Recall Bulletin

PRODUCT SAFETY RECALL

SUBJECT: Transmission Shift Cable Fracture

MODELS: 2004-2007 Chevrolet Malibu Maxx
2004-2008 Chevrolet Malibu
2005-2008 Pontiac G6
2007-2008 Saturn AURA
Equipped with 4-Speed Automatic Transmission (ME7/MN5)

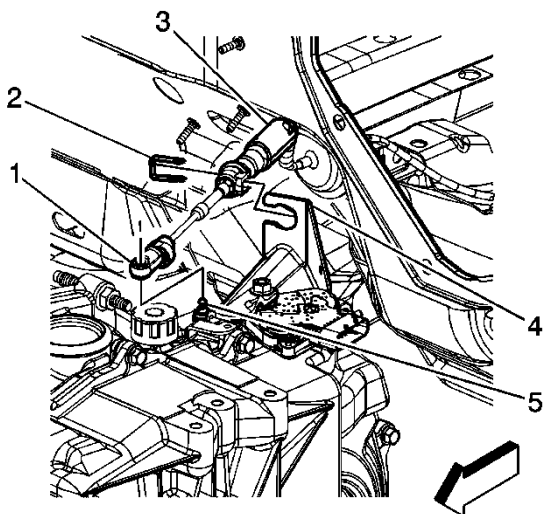
2. Remove and discard the shift cable bracket (4) and retainer (2) attached to the transmission.

3. Install a new floor shift control cable and new bracket. Refer to *Floor Shift Control Cable Replacement* or *Range Selector Lever Cable Replacement* in SI.
